8.6. Beaches Link and Gore Hill Freeway Connection EIS Submission

To seek endorsement to submit a formal response to the Department of Planning, Industry and Environment regarding the Beaches Link and Gore Hill Freeway Connection (BL&GHF) Environmental Impact Statement (EIS).

BL&GHF technical working paper: Traffic and Transport (Jacobs 2020)

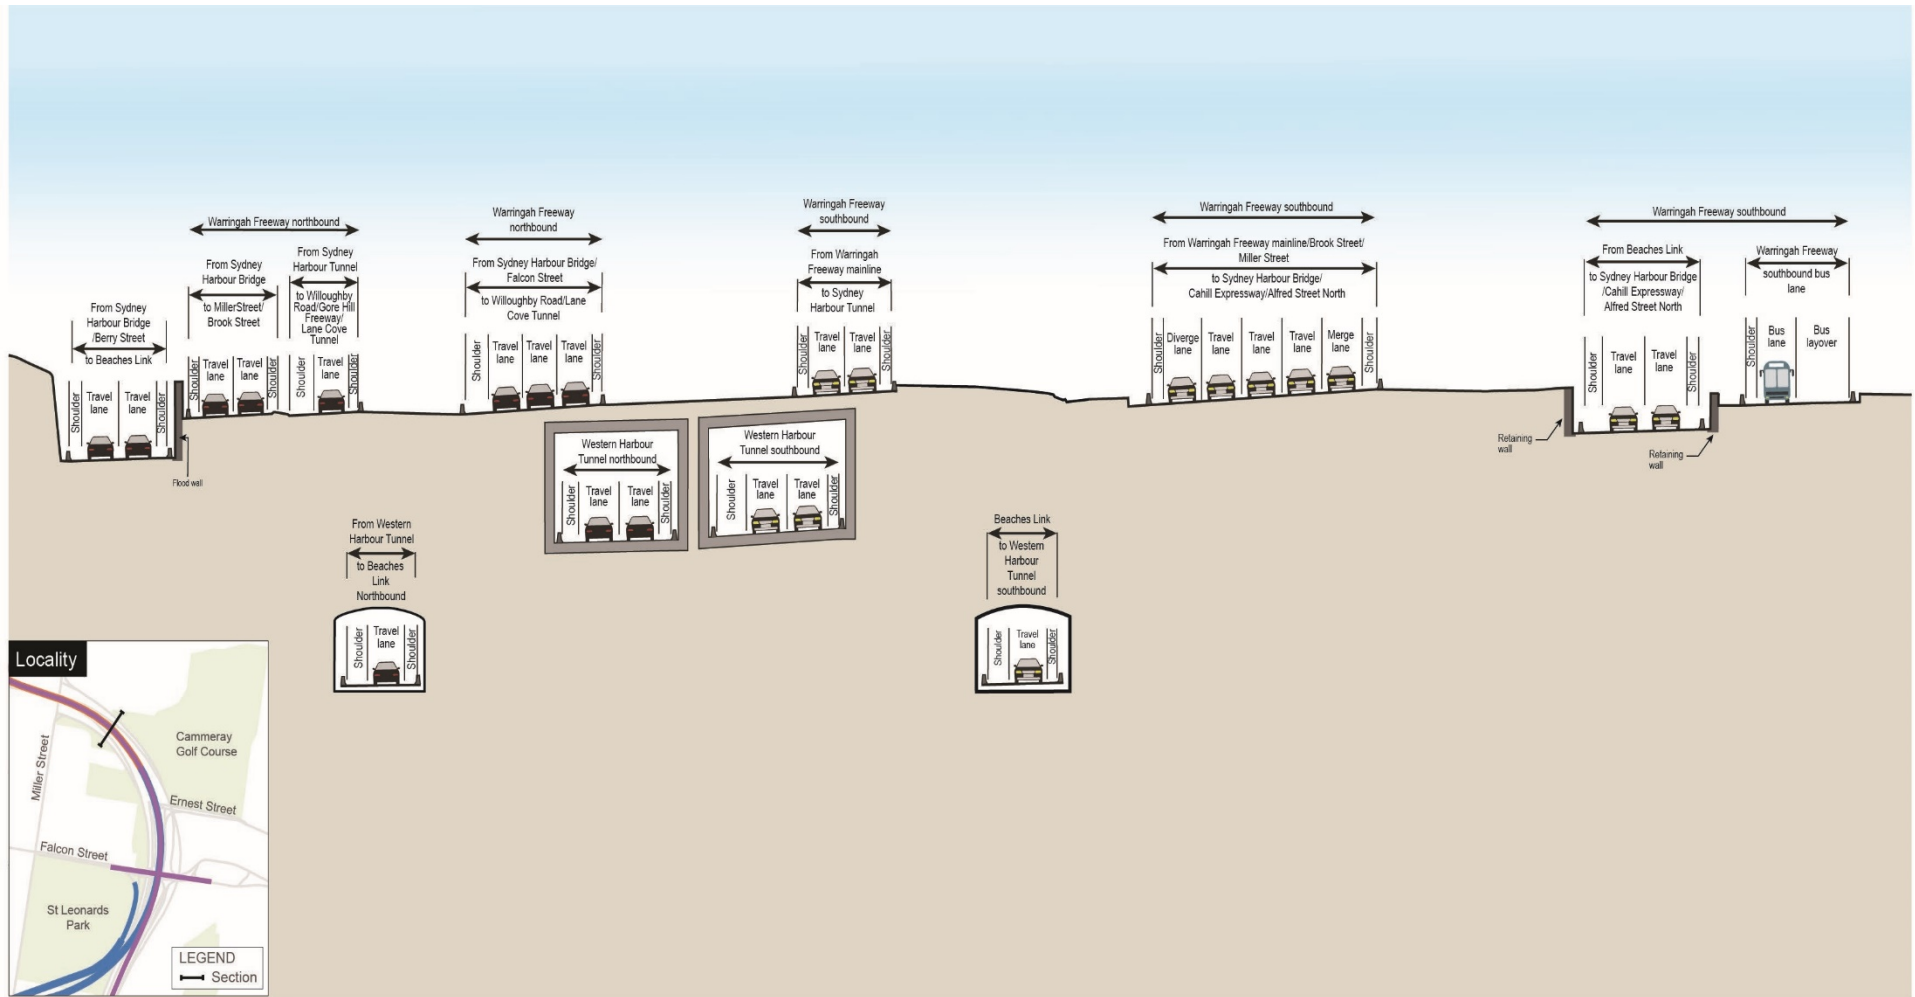
This does not mean that the BL&GHF proposals have any less of an impact on North Sydney amenity or the function of its local traffic network, with significant additional Lower North Shore traffic using the Pacific Highway (southbound), Berry Street and proposed Warringah Freeway access lanes to access the northbound BL portal on the Warringah Freeway.
